NOTICE OF A REGULAR MEETING OF THE  
KETCHUM PLANNING AND ZONING COMMISSION  
MONDAY, JUNE 8, 2015, 5:10 P.M.  
331 WEST SIXTH STREET, 154 IRENE STREET  
AND KETCHUM CITY HALL  
480 EAST AVENUE NORTH, KETCHUM, IDAHO

**STAFF REPORT**  
**KETCHUM PLANNING AND ZONING COMMISSION**  
**REGULAR MEETING OF JUNE 8, 2015**

**PROJECT:** Foxhole Townhomes Design Review

**FILE NUMBER:** #15-050

**D1**  
A-110  
**PROPOSED SITE PLAN**  
SCALE: 1/8" = 1'-0"

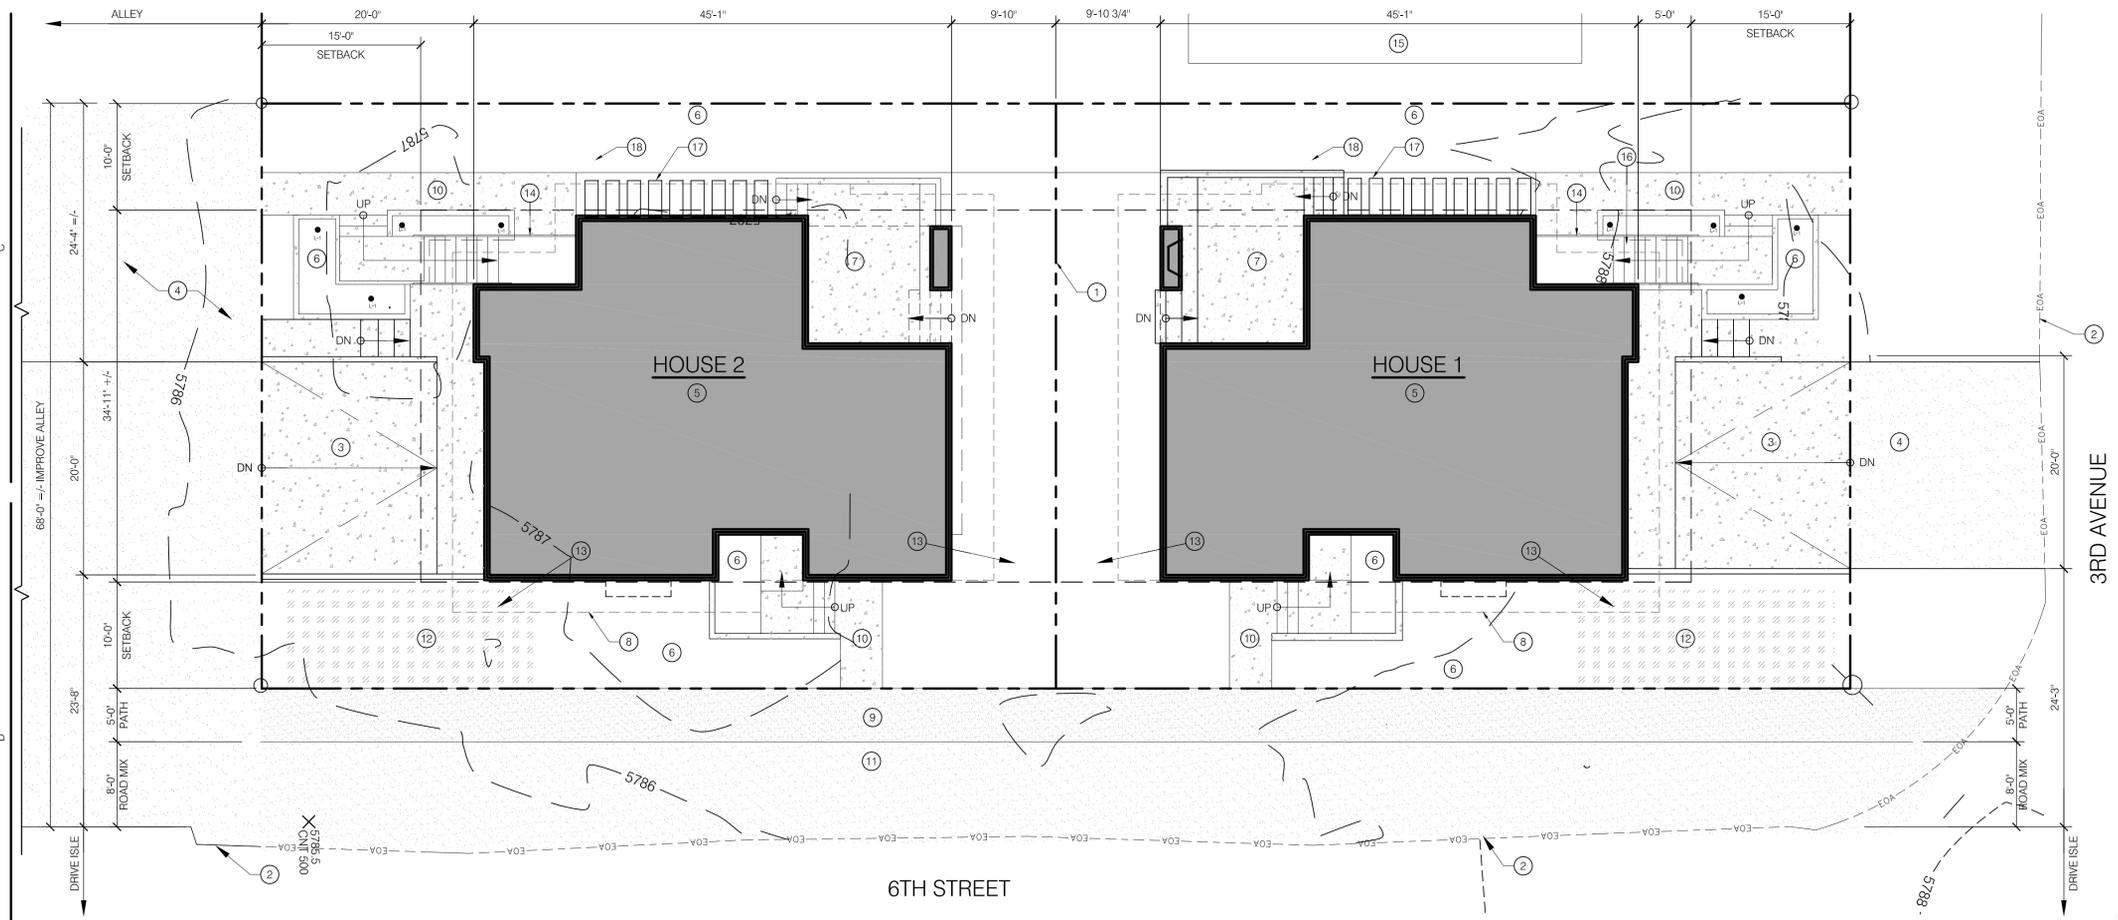
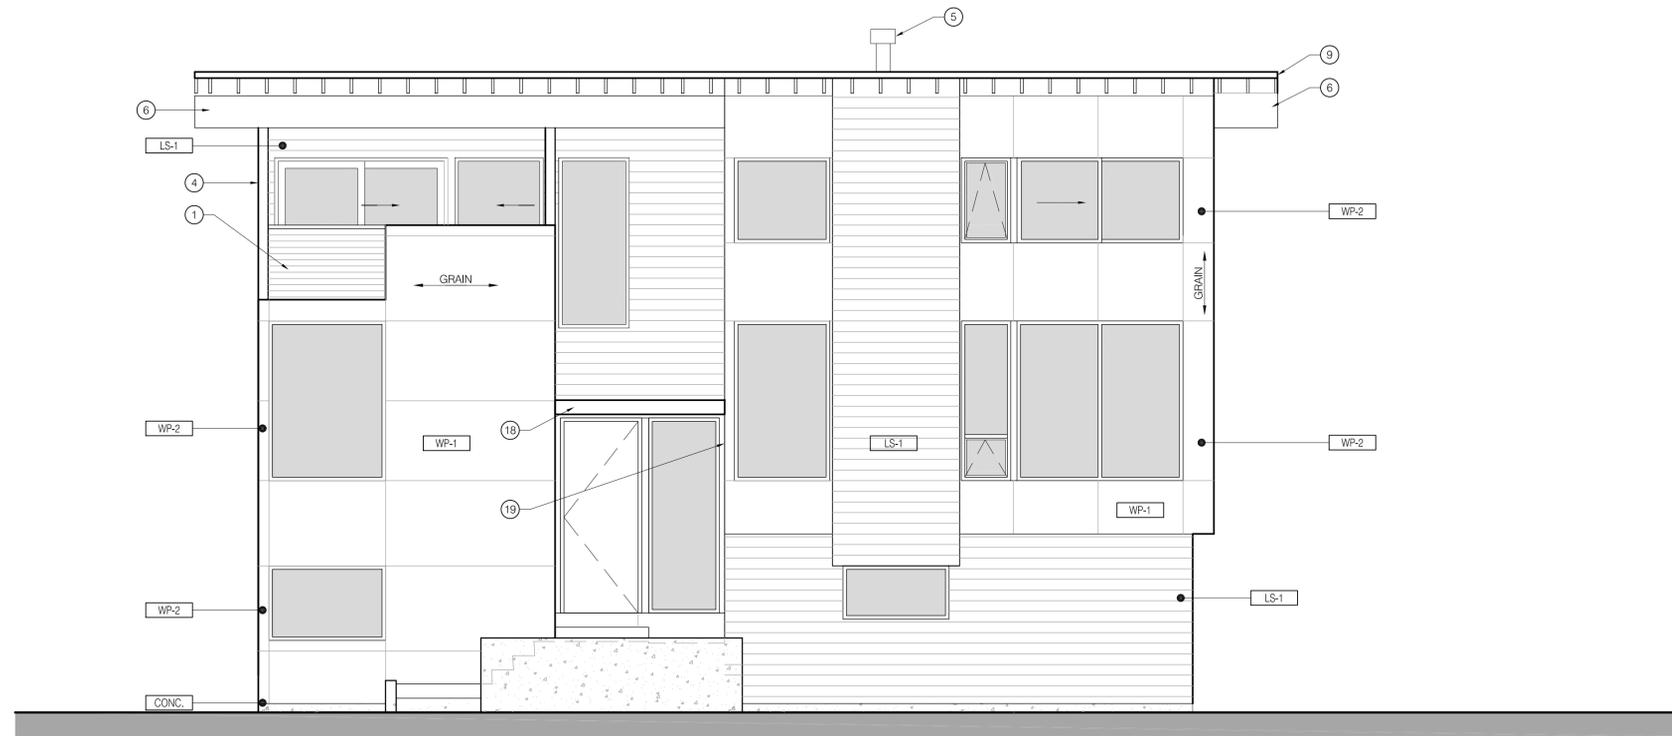
<p><b>City Arborist</b></p> <ul style="list-style-type: none"> <li>○ The city arborist visited the property and recommends total removal of trees along 6<sup>th</sup> Street. He indicated that inappropriate tree species were originally planted under the power line.</li> <li>○ The north side of the property needs to be thinned out or replanted. The evergreen trees are currently overgrown.</li> <li>○ The two large spruce trees located in the middle of the project are worth saving.</li> <li>○ The landscaping plan needs to allow for visibility at the corner of 6<sup>th</sup> Street and 3<sup>rd</sup> Avenue.</li> </ul>
			<p><b>Building:</b></p> <ul style="list-style-type: none"> <li>○ Two separate building permits – one per unit – will be required.</li> <li>○ A demolition permit is required.</li> </ul>
			<p><b>Planning and Zoning:</b></p> <ul style="list-style-type: none"> <li>○ The proposed driveway width on 3<sup>rd</sup> Avenue is slightly more than is allowed (35%) and will need to be reduced to 19.23 feet or less. The plans currently indicate a width of 20 feet.</li> </ul>

5. The proposed driveway of house one as depicted in the site plan shall not exceed 35% of the total lot street frontage of 3<sup>rd</sup> Avenue.
6. If a building permit is not obtained and construction has not commenced by October 31, 2015, the applicant shall revegetate and otherwise restore any disturbed areas with perennial vegetation or other ground cover found sufficient by the Planning Director to stabilize soil by October 31, 2015.
